CAIRNGORMS NATIONAL PARK AUTHORITY

DEVELOPMENT PROPOSED: CRAIG WATCH WIND FARM

Consultation from Scottish Government Energy Consents & Deployment Unit

REFERENCE: 2022/0217/PAC (ECU00002177)

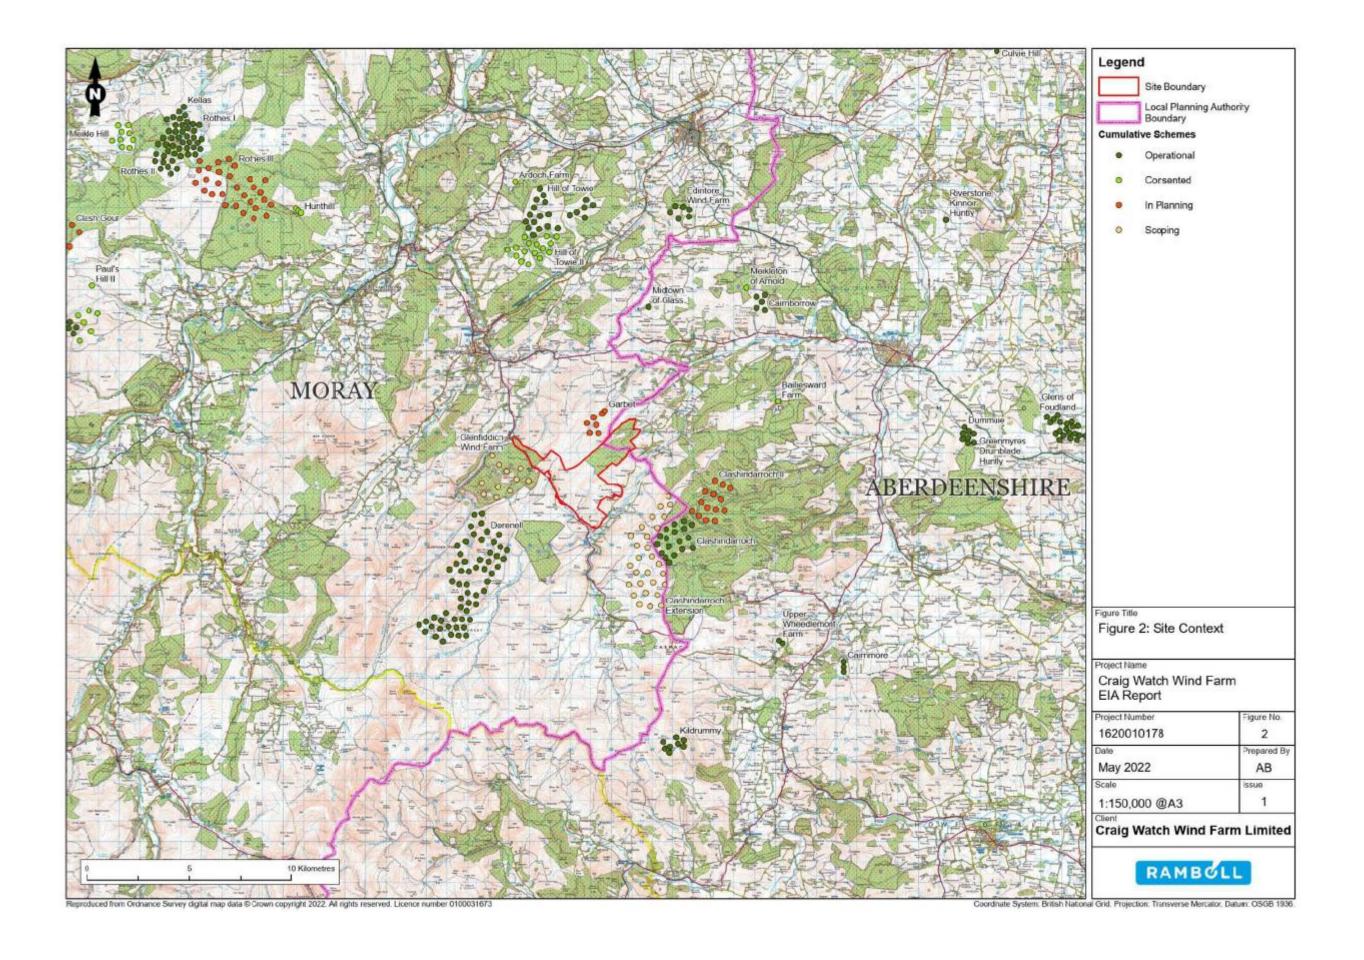
- 4. The majority of the proposed wind farm would be located in the 'limb' of the red line boundary pointing to the north east that is mapped as forestry, approximately 8 km south east of Dufftown, indicated in the applicant's ER figure 2 on page 2 of this report. As also shown in the figure, in the surrounding area there are numerous other existing and consented wind farms, plus several proposed wind farms in the planning system.

- 33. There are several existing and consented wind farms in the area surrounding the proposed wind farm, as shown on page 2 of this report. Adding the proposed Craig Watch wind farm to the baseline would not significantly add to the existing level of effects, either alone or in combination with other existing or consented wind farms.
